FINAL EXPRESS TERMS
FOR
PROPOSED BUILDING STANDARDS
OF THE
DEPARTMENT OF HOUSING AND COMMUNITY DEVELOPMENT
REGARDING PROPOSED CHANGES TO THE 2007 CALIFORNIA BUILDING CODE (CBC)
CALIFORNIA CODE OF REGULATIONS, TITLE 24, PART 2
(HCD 02/07)

The Department of Housing and Community Development (HCD) proposes to make necessary changes to the 2007 edition of the California Building Code (CBC), based on the 2006 International Building Code (IBC), as presented on the following pages. HCD further proposes to:

FIGURE 11A-6A—WARNING STRIPING AND HANDRAIL EXTENSIONS

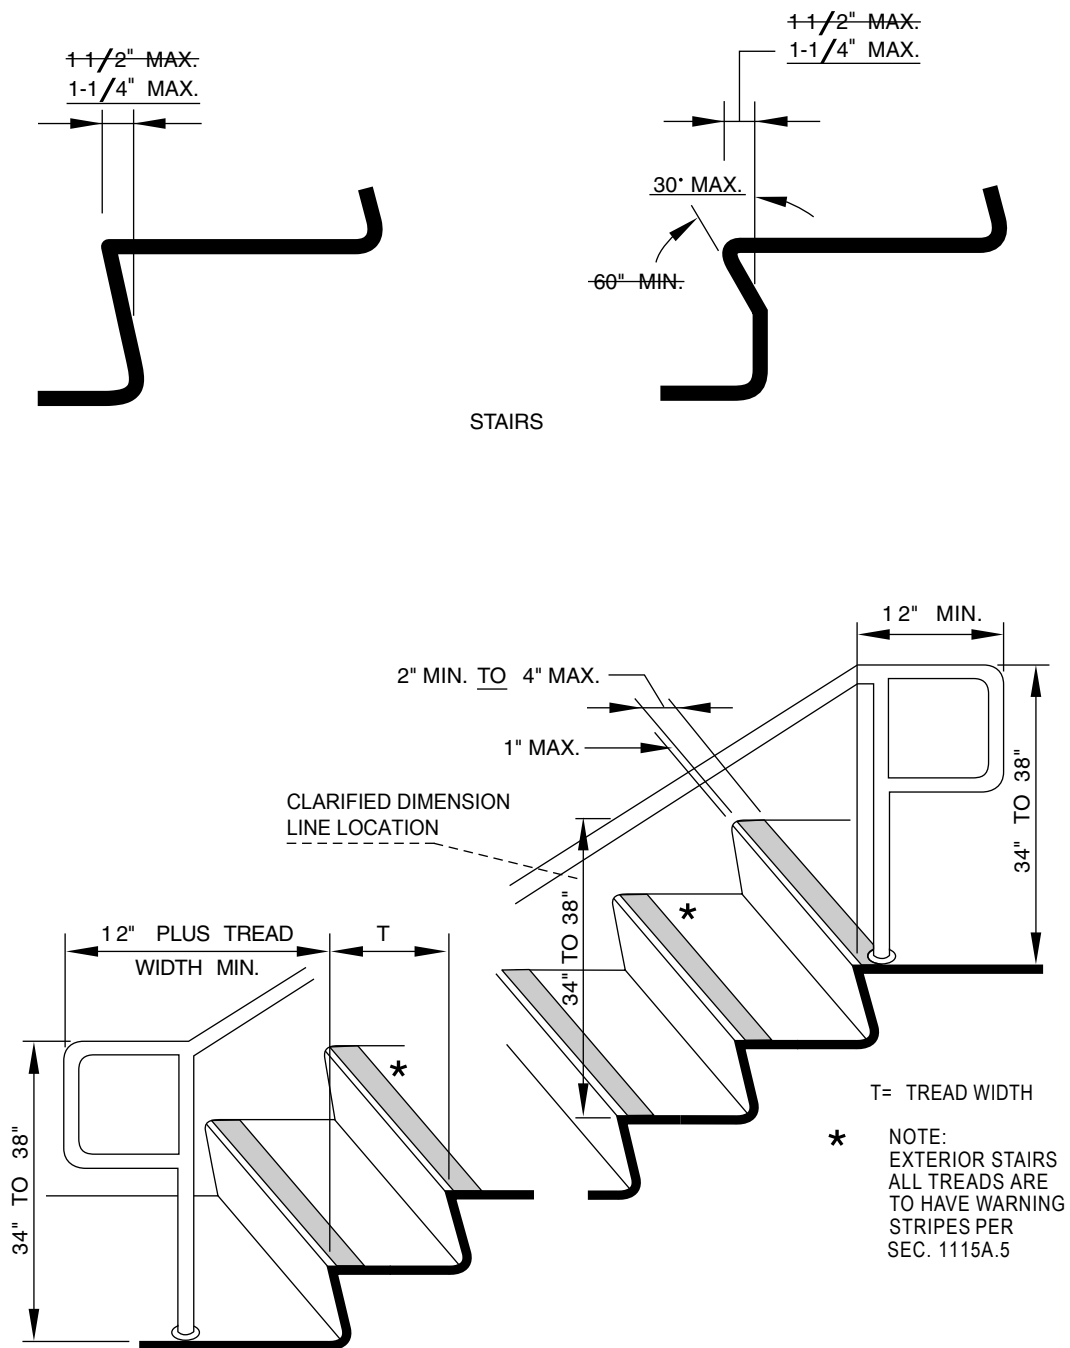
1115A.4 Nosing. Nosing shall not project more than ~~4 1/4~~ 1 1/4 inches (~~38.4~~ 31.8 mm) past the face of the riser below. Risers shall be sloped or the underside of the nosing shall have an angle not ~~less~~ more than 60 30 degrees (0.52 rad) from the ~~horizontal~~ vertical. (See Figure 11A-6A).

1123A.4 Nosing. Nosing shall not project more than ~~4½~~ 1½ inches (~~38.1~~ 31.8 mm) past the face of the riser below. Risers shall be sloped or the underside of the nosing shall have an angle not less ~~more than 60~~ 30 degrees (0.52 rad) from the ~~horizontal~~ vertical. (See Figure 11A-6A).

33. Amend Figure 11A-6A “WARNING STRIPING AND HANDRAIL EXTENSIONS”:

FIGURE 11A-8J – PLATFORM AT SECONDARY EXTERIOR DOOR

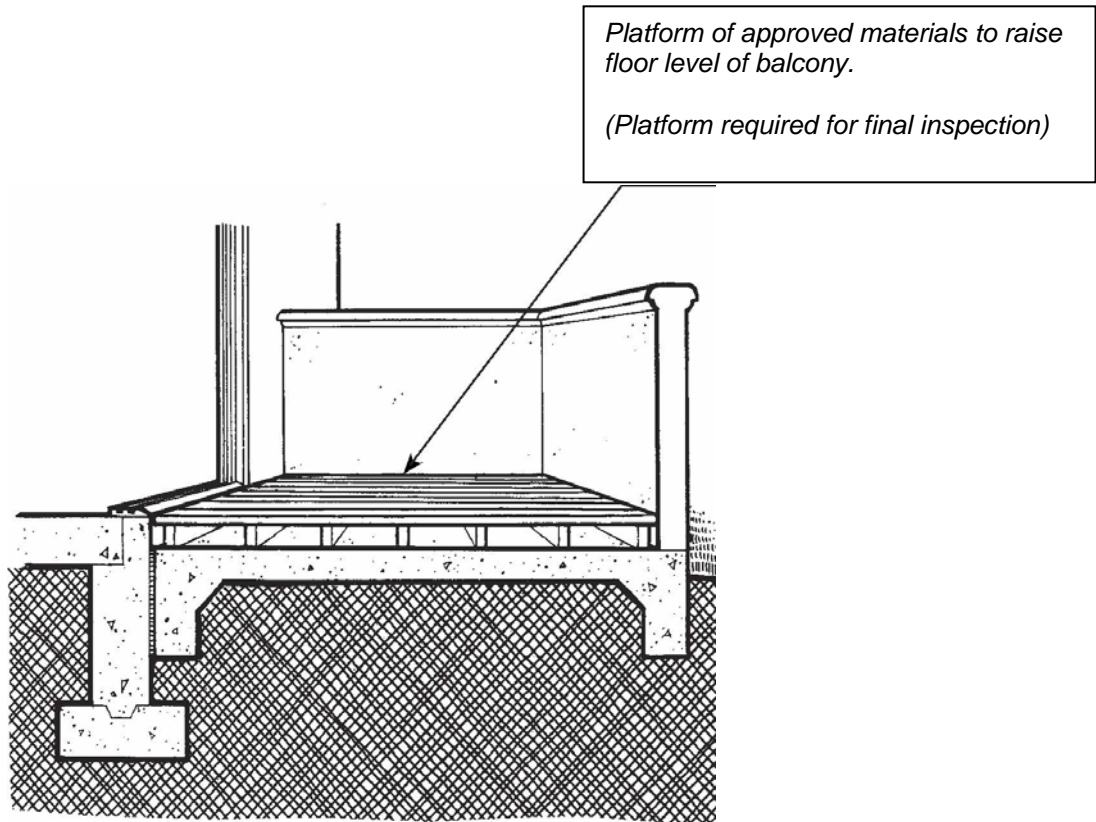
3. Secondary exterior doors onto decks, patios or balcony surfaces constructed of impervious materials (e.g., concrete, brick, flagstone) may have a maximum change in height from the interior landing of 4 inches (101.6 mm). Changes in height greater than ½ inch (12.7 mm) shall be accomplished by means of a ramp complying with Section 1114A or by means of a platform constructed to the level of the floor as illustrated in Figure 11A-8J.

Figures 11A-8J “Platform at Secondary Exterior Door”; 11A-8K “Ramp at Secondary Exterior Door”; 11A-9L “Shower with Water Closet”; and 11A-9M “Wing Wall or Cabinet at Water Closet” are added (see attached.)

FIGURE 11A-8K – RAMP AT SECONDARY EXTERIOR DOOR

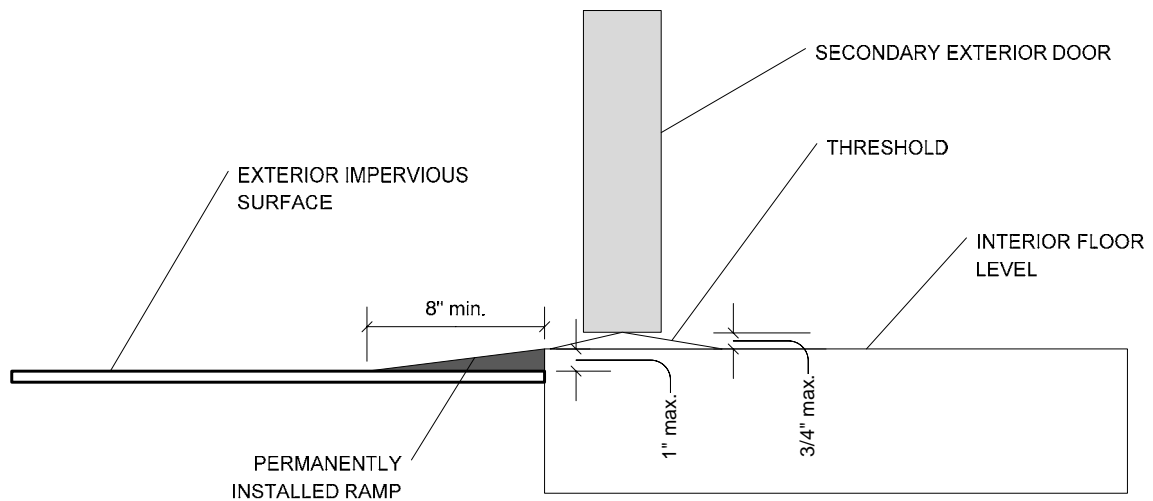
4. Secondary exterior doors onto decks, patios or balcony surfaces constructed of impervious materials (e.g., concrete, brick, flagstone) may have a maximum change in height from the interior landing of 1 inch (25.4 mm), provided a ramp with a maximum slope of 1:8 is permanently installed. (See Figure 11A-8K.)

FIGURE 11A-9L – SHOWER WITH WATER CLOSET

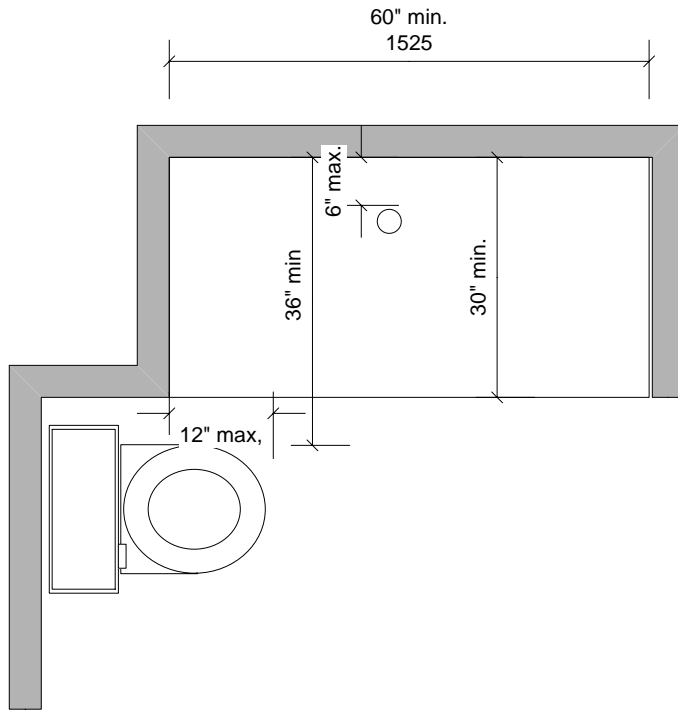
1.2 The shower stall shall measure at least 30 inches deep by 60 inches wide (762 mm by 1524 mm) with an entrance opening of at least 60 inches (1524 mm). A water closet may project a maximum of 12 inches (305 mm) into the opening provided that a minimum of 36 inches (914 mm) clear space is maintained between the water closet and the shower wall as illustrated in Figure 11A-9L or;

FIGURE 11A-9M – WING WALL OR CABINET AT WATER CLOSET

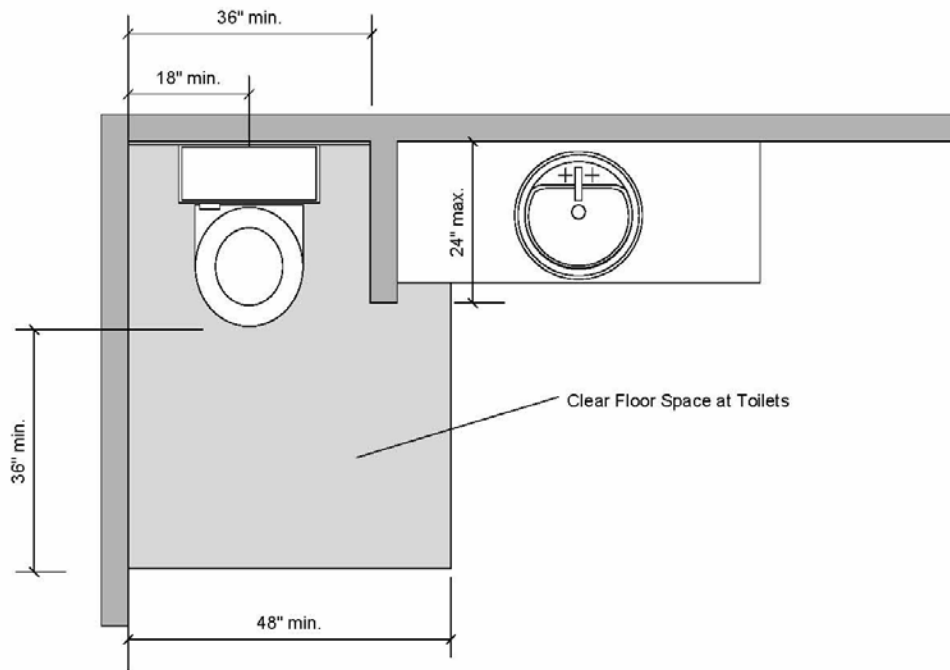
1. **Floor Space.** ~~The water closet shall be located in a space a minimum of 36 inches (914 mm) in clear width with 48 inches (1219 mm) minimum clear space provided in front of the water closet. This space may include maneuverable space under a lavatory, if provided and arranged so as not to impede access. The minimum floor space provided at a water closet shall be 48 inches (1219 mm) in clear width. The clear floor space shall extend past the front edge of the water closet at least 36 inches (914 mm). See Figure 11A-9M.~~
